May 28, 2025

PERFORMANCE BULLETIN 144 K526 and K5524 Cap Screw Update

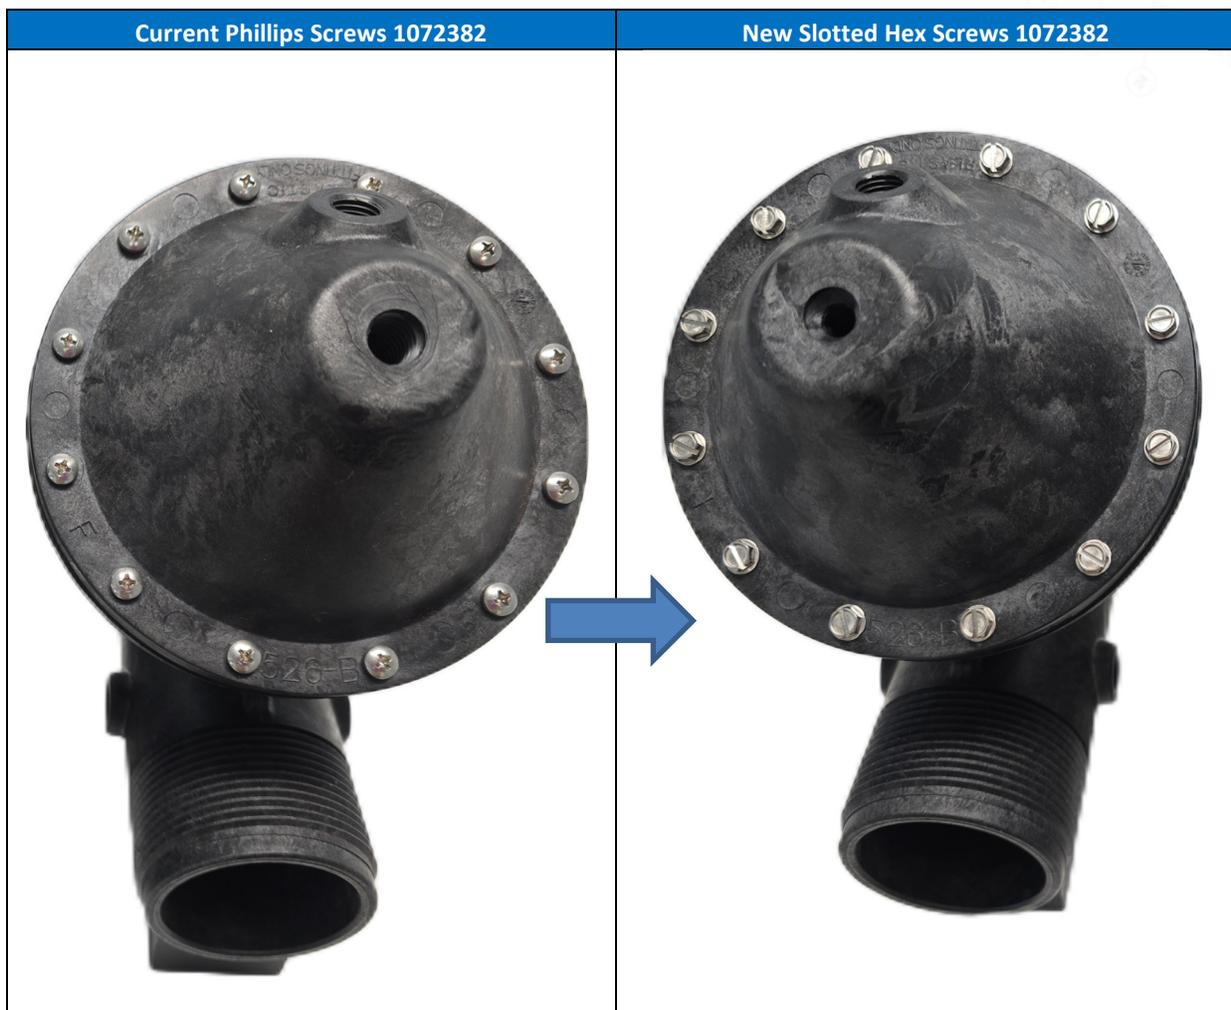
The screw Part Number 1072382 used to secure K526 and K5524 cap to body are being changed to a slotted hex head. A 5/16" socket or flat head screwdriver can be used to remove or install the new screws.

The change is being made to ease manufacturing and does not affect the function. The Part Number will remain unchanged.
